**RESPONSE TO QUESTIONS 1, 2, 3, 4, 5, 7,
10, 11, 12, 13, 14, and 16**

August 1989

Pacific Gas and Electric Company

Diablo Canyon Power Plant
Long Term Seismic Program

Figure Q2-1

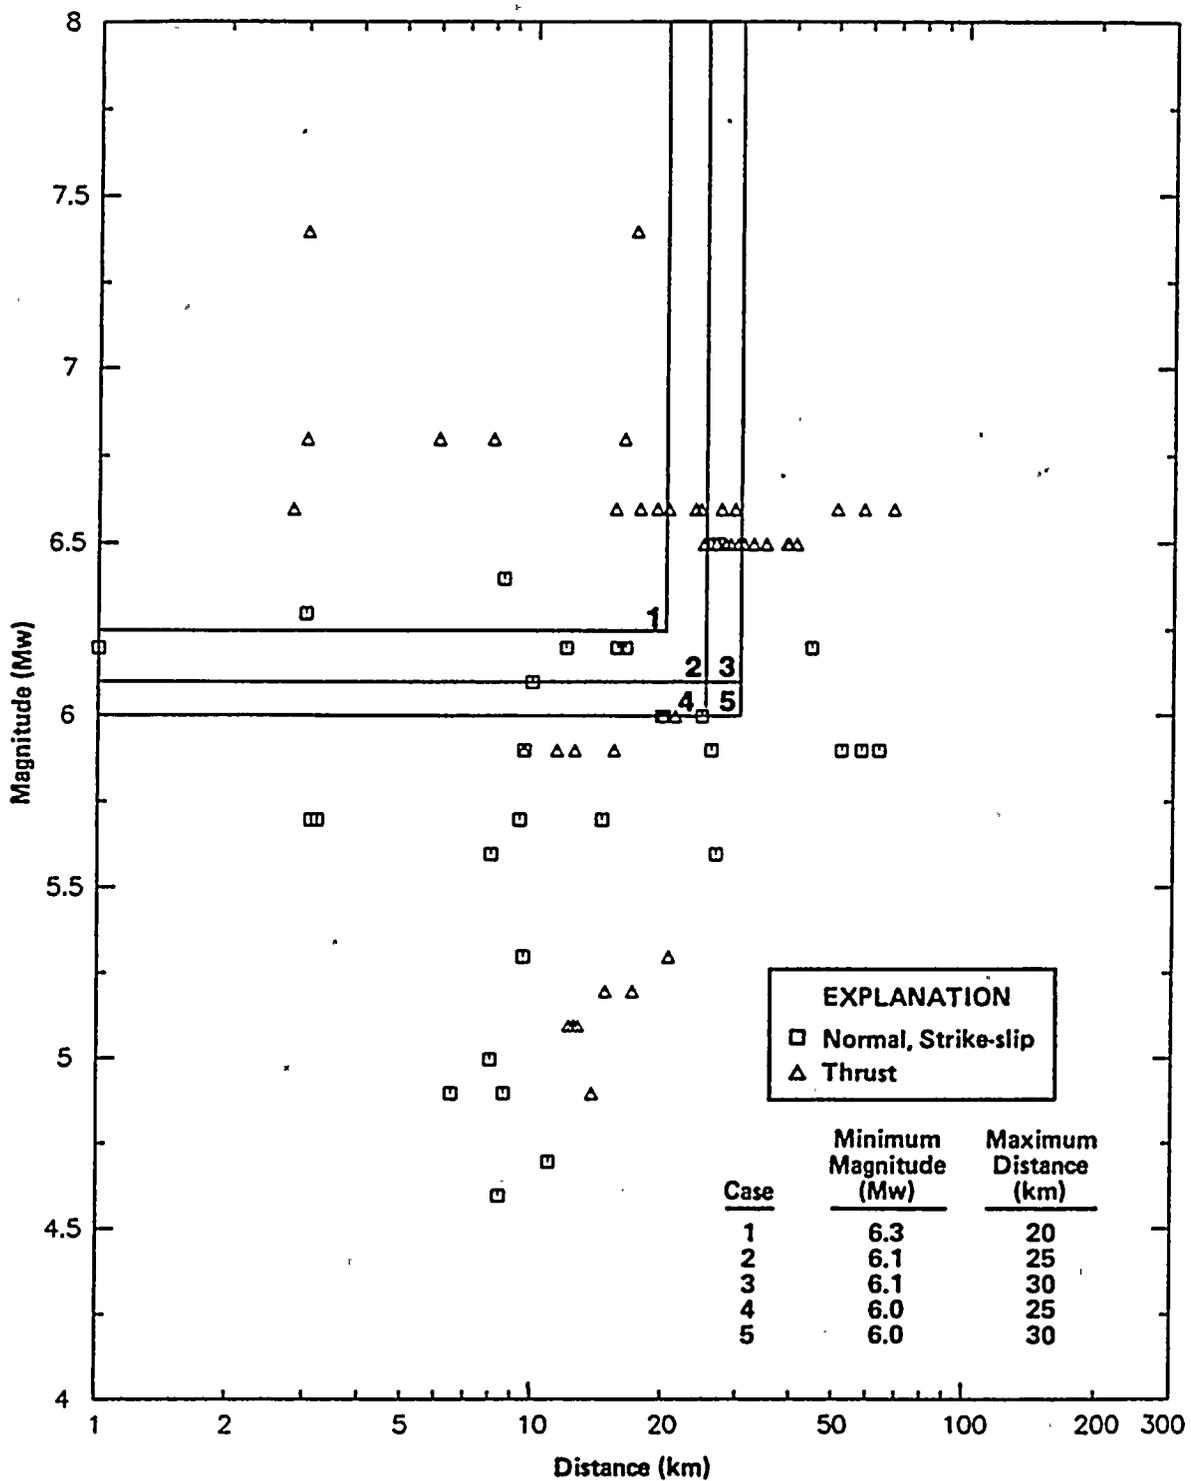
Provide a justification of the methods used for the selection and adjustment of the data used in the near-source ground motion and empirical ground motion estimates. The justification should demonstrate that the methods used do not bias the ground motion to the low side.

magnitude range to include earthquakes having magnitudes as low as 6.0 and 6.1, and we extended the source-to-site distance range to include recordings within 25 km and 30 km, respectively. As a result, five sets of recordings (including the original set presented in the Final Report) were used in the analyses. The number of records in each set and their composition are listed in Table Q2-1. A plot showing the magnitude versus distance distribution of the recordings is presented on Figure Q2-1.

Figure Q5-1

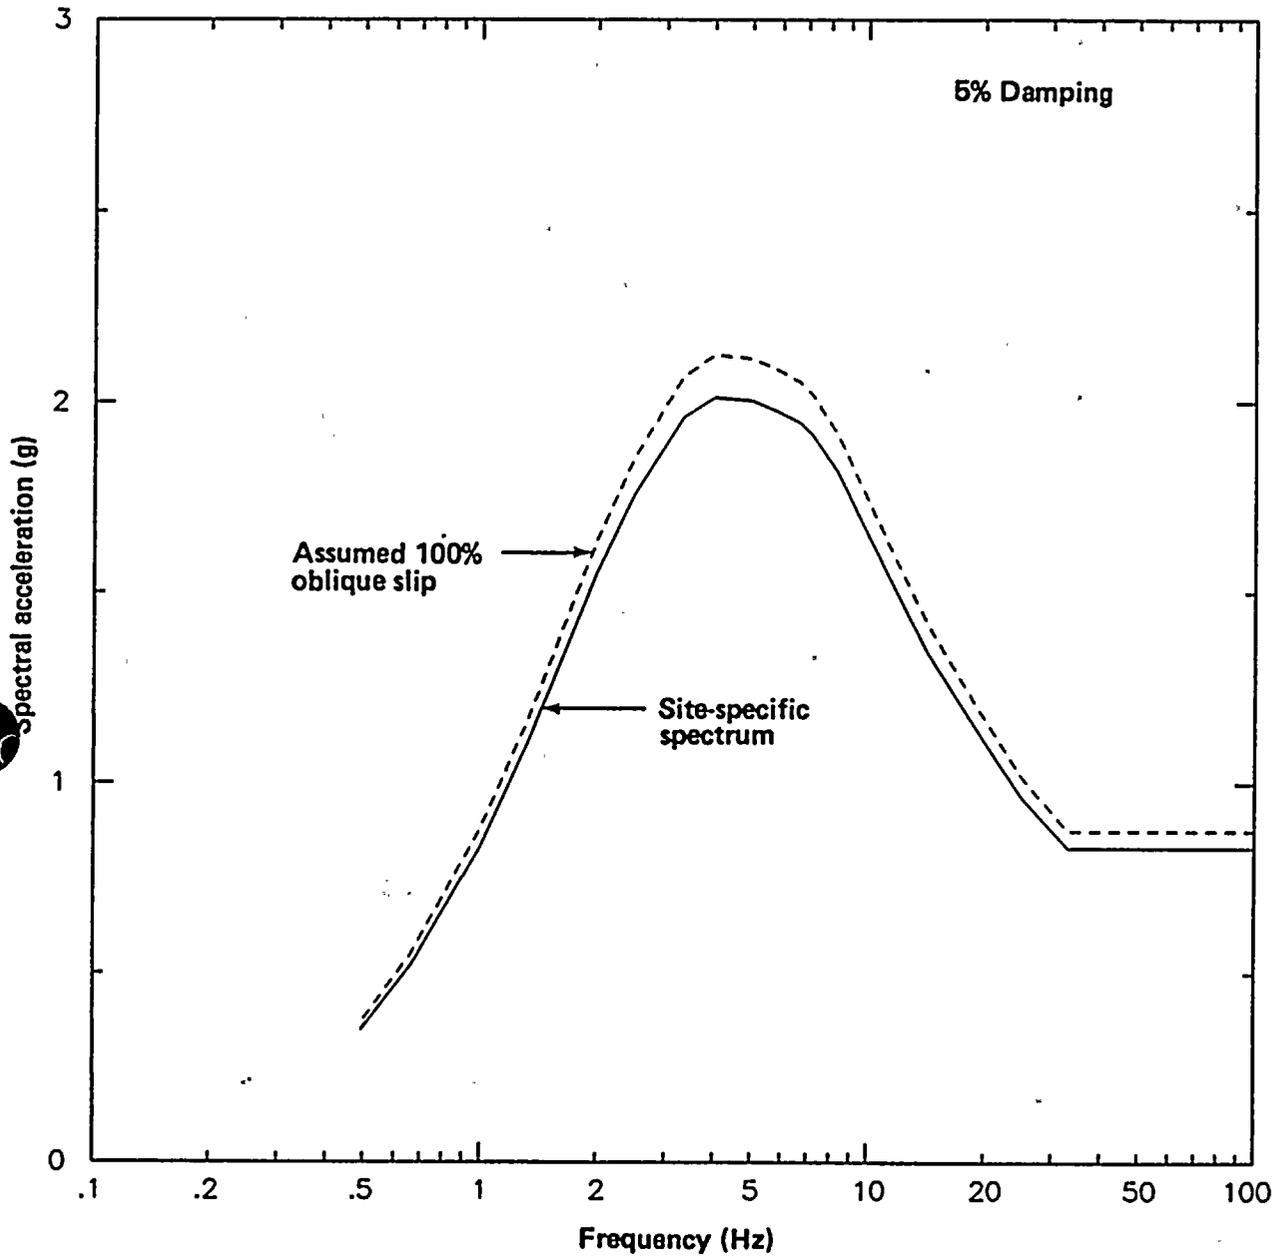
How much would the empirical ground motion estimates change if the type of faulting was assumed to be all oblique slip rather than 65% strike slip, 30% oblique slip, and 5% reverse slip?

In response to Question 5, results have been generated for an assumed case in which the weights are strike slip, 0; oblique slip, 1.00; and thrust, 0. The response spectrum for this assumed case is shown on Figure Q5-1. The difference between the response spectrum for this assumed case and the site-specific response spectrum is about 5 percent.

Figure Q12-3

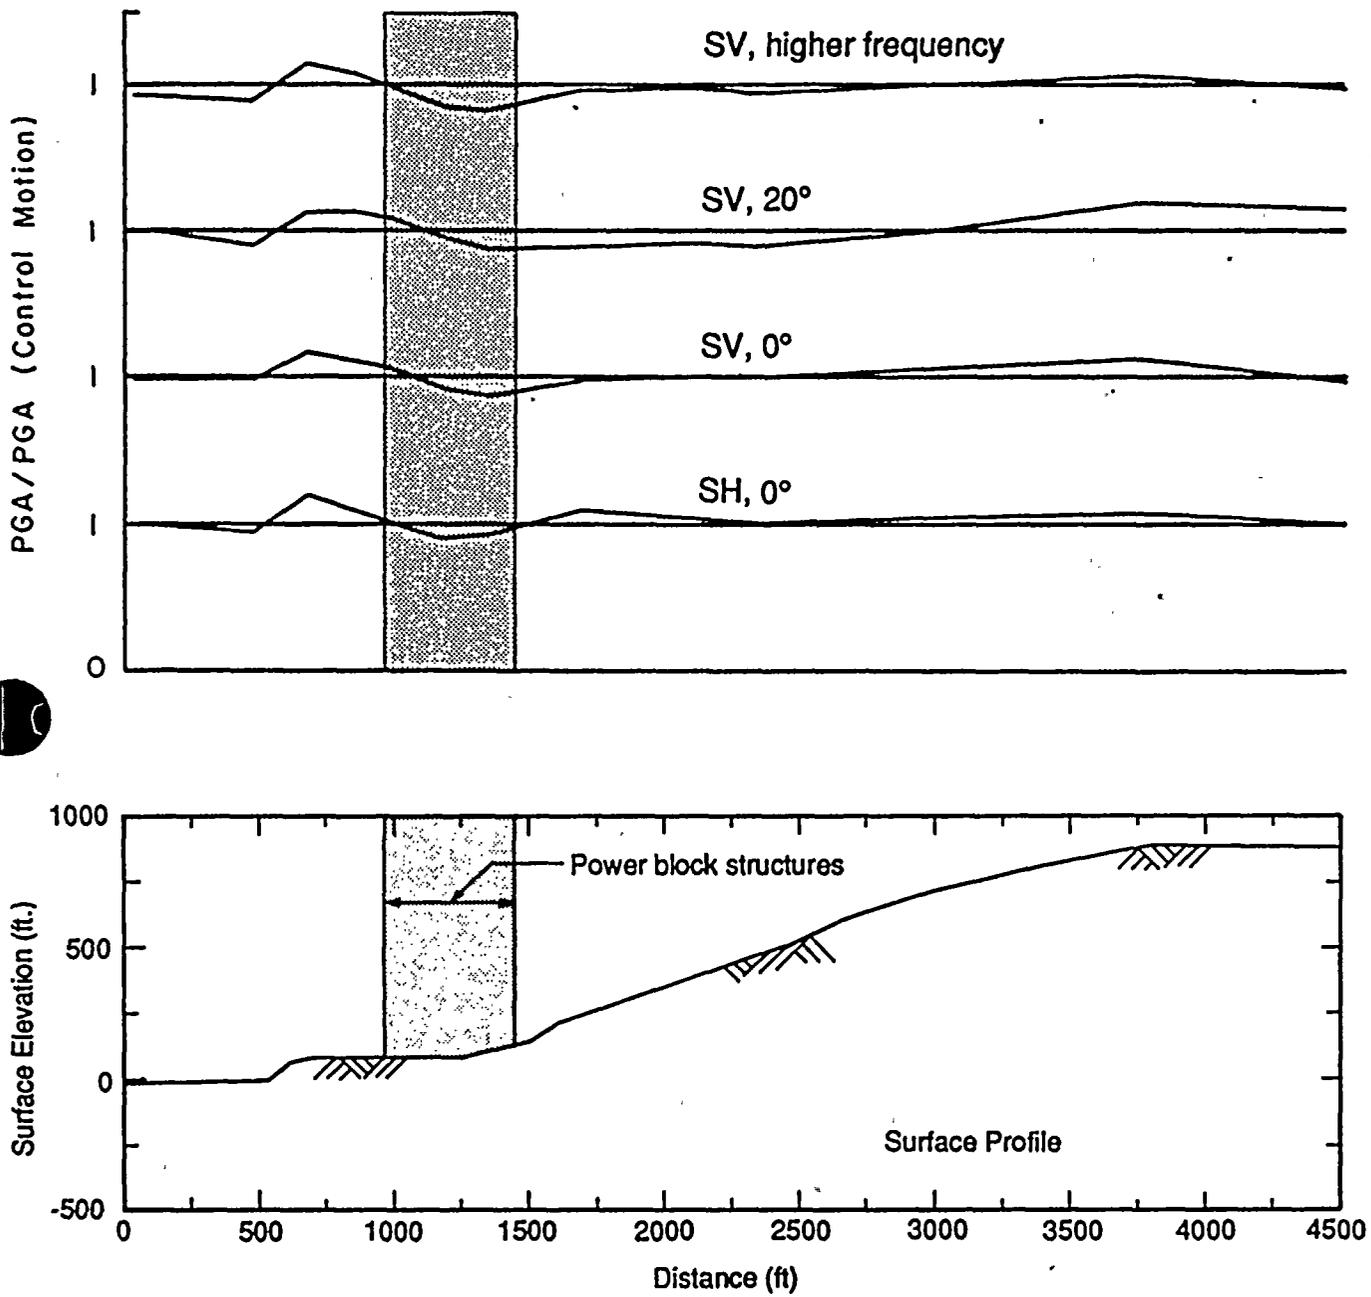
To aid in assessing the proposed lack of topographic effect at the Diablo Canyon site, provide a numerical study using vertically polarized shear waves with ground motion amplitude referenced to sea level.

Figure Q12-3 shows the response of the site region for a series of different input ground motions. The response is represented by the ratio of peak acceleration for the model having topography to the peak acceleration for the model having no topography, which defines the free-field control motion. The response of the site region to a vertically propagating SV wave shows a slight deamplification at the base of the sea cliff and a peak amplification of about 17 percent at its crest. The motion at the location of the power block structures is generally deamplified; at its greatest, the deamplification is about 15 percent.

The response to a vertically propagating SH wave is very similar to that for a vertically propagating SV wave (Figure Q12-3). For both SV and SH waves, the topography causes amplification near the crests of the sea cliff and the ridge, and deamplification near the bases of the sea cliff and the ridge.

Figure Q13-1

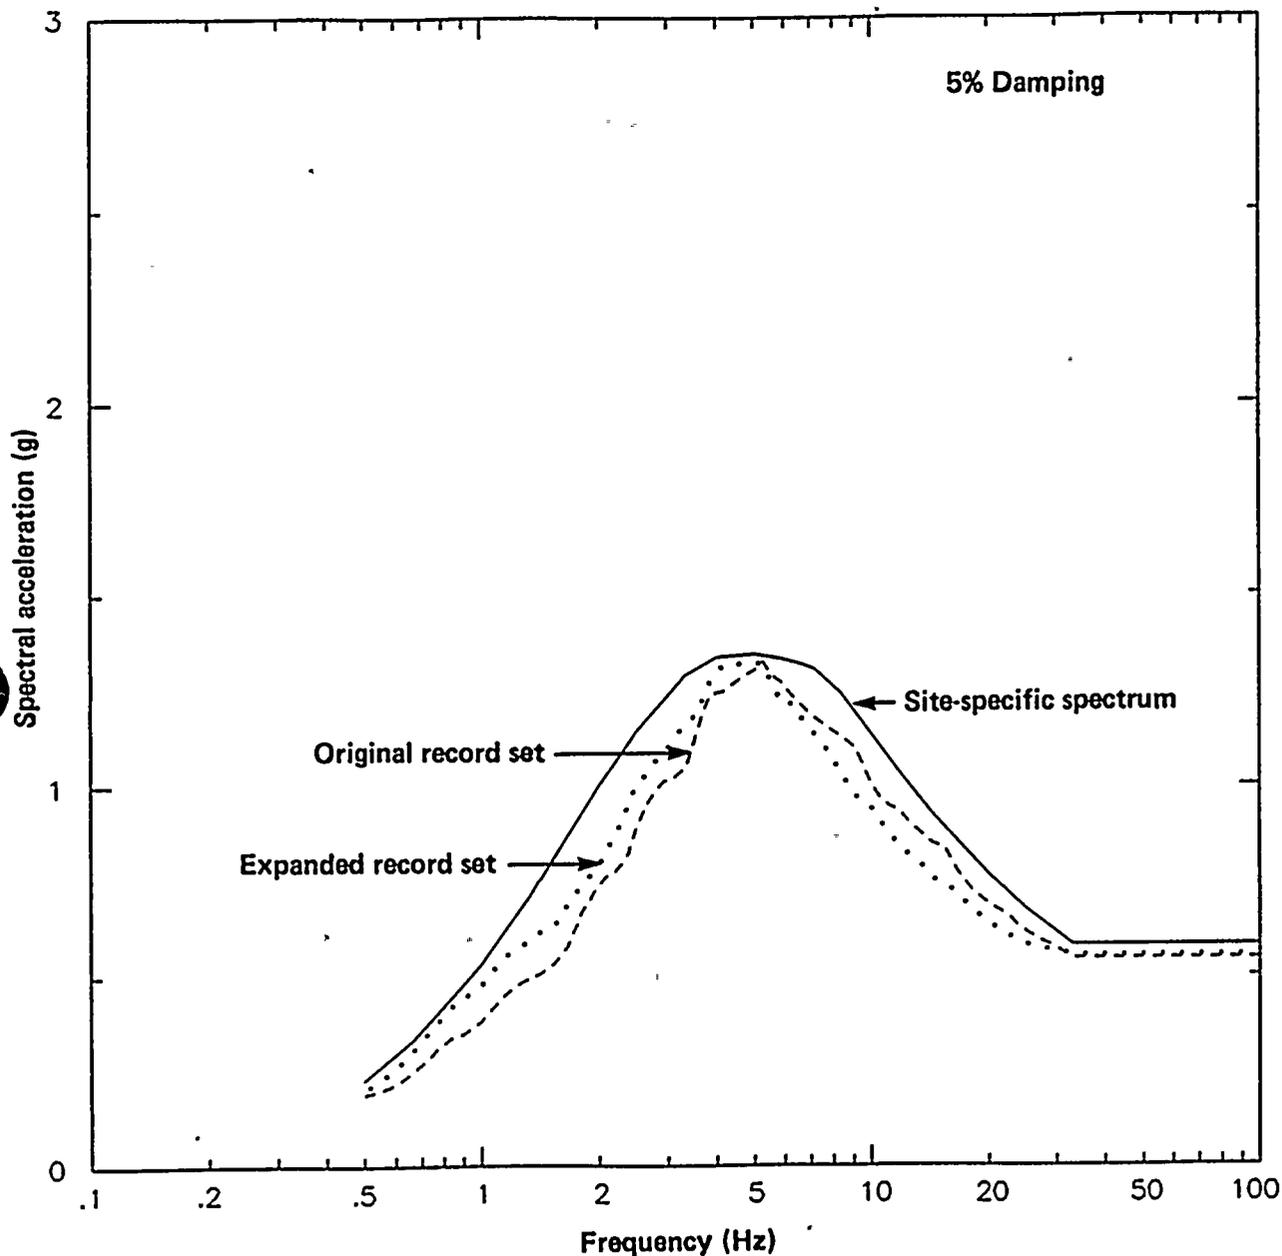
Limits on parameters used to establish the empirical data base appear to be constrained to the point where some earthquakes which may be important are not included. To determine the significance of the choice of magnitude and distance ranges to the LTSP site specific spectra, expand the data base to include earthquakes down to magnitude 6, particularly the Parkfield and Morgan Hill events, and distances to about 30 kilometers and provide the resulting spectra.

As can be seen from Figures Q13-1 and Q13-2, the spectra presented in the Final Report derived from near-source statistics provide equal or more conservative estimates in the high frequency range (about 5 to 25 Hz). At lower frequencies (less than 5 Hz), the response spectra obtained using the expanded selection criteria provide more conservative estimates of ground motions. A more relevant comparison is with the site-specific spectra based on the regression analysis. This comparison shows that the site-specific response spectra essentially equal or envelop the other spectra over the entire frequency range at the median level, and over a frequency range of about 1.5 to 25 Hz at the 84th-percentile level.

Figure Q14-1

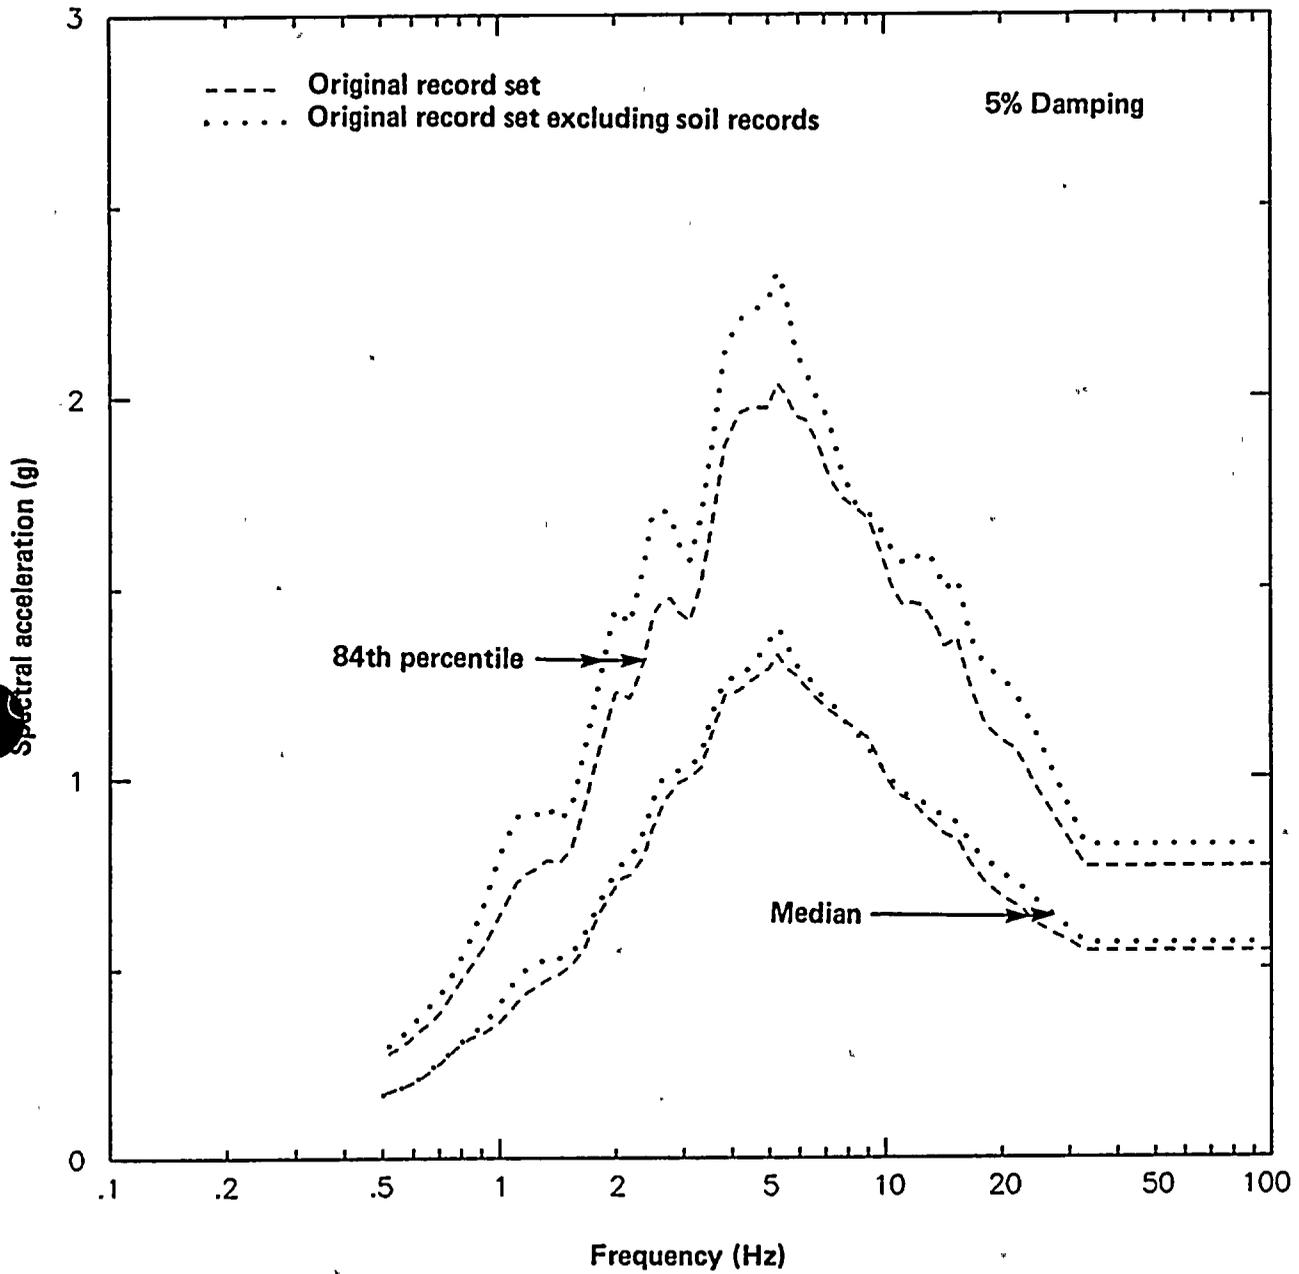
Since the Imperial Valley earthquake data were recorded on deep soil sites, their use in developing the site specific response spectra for Diablo Canyon has been questioned. Provide site specific response spectra obtained without the use of the Imperial Valley earthquakes.

In response to the current question, a sensitivity study was performed of the set of near-source records, excluding the five Imperial Valley records. The results are compared with those for the original 18-record set, in terms of 5 percent damped spectral acceleration, on Figure Q14-1 for the median and the 84th-percentile levels. As can be seen from Figure Q14-1, the agreement between the two spectra at the median level is very close, differing by less than 4 percent for the peak ground acceleration values, about 2 percent for the spectral acceleration values averaged over the 3 to 8.5 Hz frequency band, and about 4 percent for the spectral acceleration values averaged over the 5 to 14 Hz frequency band. At the 84th-percentile level, Figure Q14-1 shows the differences are about 7 percent for the peak ground acceleration values, about 9 percent for the spectral acceleration (3 to 8.5 Hz) values, and slightly less than 10 percent for the spectral acceleration (5 to 14 Hz) values. The somewhat larger differences observed at the 84th-percentile level may be due to the modest number of records; it is expected that there will be greater variability at the 84th-percentile level than at the median level.

Figure Q16-16

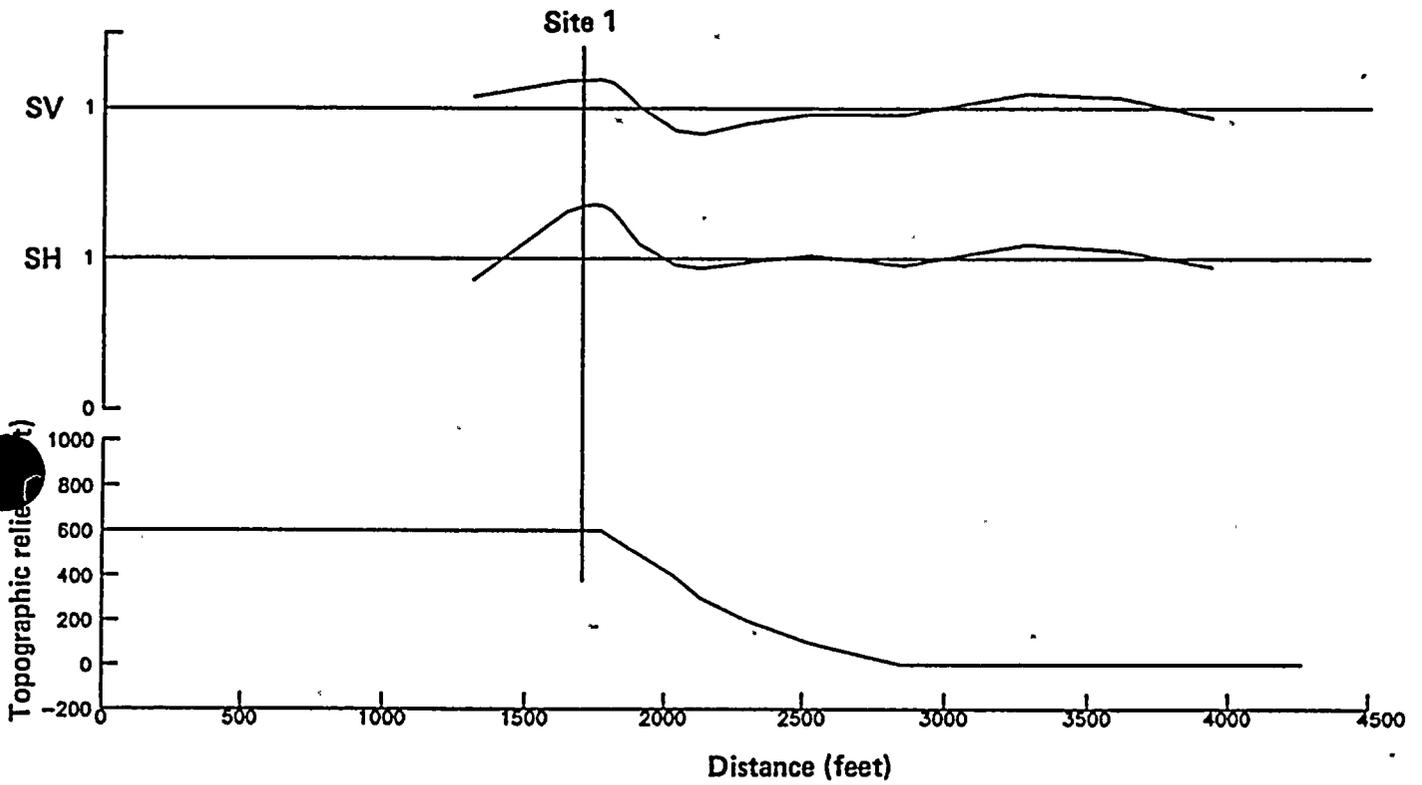
Recent work on the Nahanni earthquake Site 2 data (Weichert, 1989) and in the San Fernando earthquake Pacoima Dam recording (Anooshehpoor, 1988) indicate that the high ground motions recorded may not be due to site effects. In view of this, modification of these records to account for topographic amplification is questionable. What would the ground motion estimates be without these modifications?

To test this hypothesis, a numerical study of topographic effects at the two Nahanni sites was conducted using finite difference calculations; the results are shown in Figures Q16-16 and Q16-17. The procedure used is the same as that described in the response to Question 12 of this submittal. The topographic profiles were derived from the 1:50,000-scale elevation contour map shown in Figure Q16-15. The upper slopes of the two profiles are very similar, but Station 2 is at about 300 feet higher elevation. At each site, the accelerograph was located close to the edge of a steep slope. The ratio of peak acceleration on the ground surface to that for flat (free-field) conditions shows similar effects, with amplification of both SV and SH waves over the edges of the slopes, and some deamplification over the slopes. At the strong motion sites, there is amplification of SH by 35 and 45 percent for Stations 1 and 2 respectively, and amplification of SV by 10 and 15 percent respectively. For both SH and SV, the amplification at Station 2 is slightly larger than at Station 1. This is consistent with the observation by Weichert and Horner (1987) that the peak accelerations of the aftershocks at Station 2 are larger on the average than at Station 1. We conclude that the strong motion recordings of the Nahanni earthquake at Stations 1 and 2 were both amplified by topographic effects.
